*4.2.1. Position determination*  
*Proposed modifications*

AECS 12<sup>nd</sup>. meeting

Moscow, 9-11 February 2016

Figure 5 – Arrangement for evaluation of GNSS module sensitivity

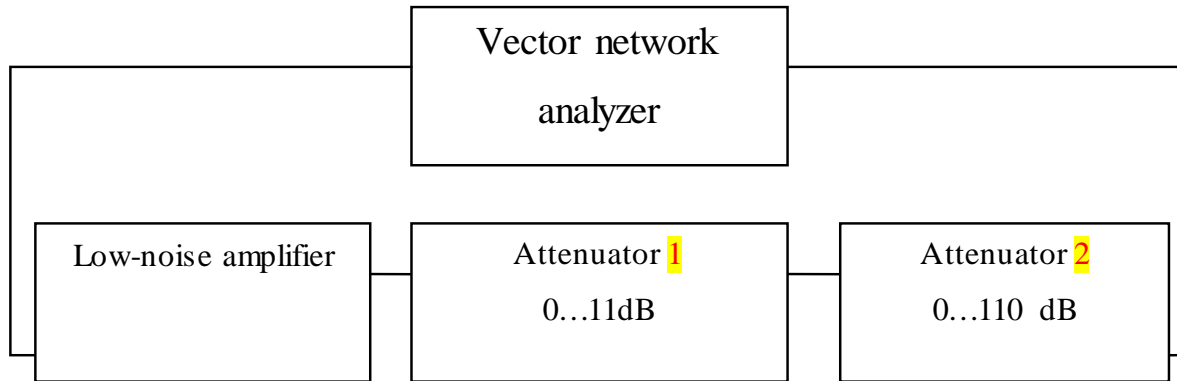
- 2.1 – It should say: **GNSS receiver** (*instead of navigation receiver*)
- 2.1.6 – It should say: **GNSS receiver** (*instead of navigation receiver*)
- 3.5.2 – It should say: **GNSS receiver** (*instead of navigation receiver*)
- 3.7 – It should say: **GNSS receiver** (*instead of navigation receiver*)
- 3.7.4 – Figure 5 should say: **AECD/AECS** (*instead of The AECD*)
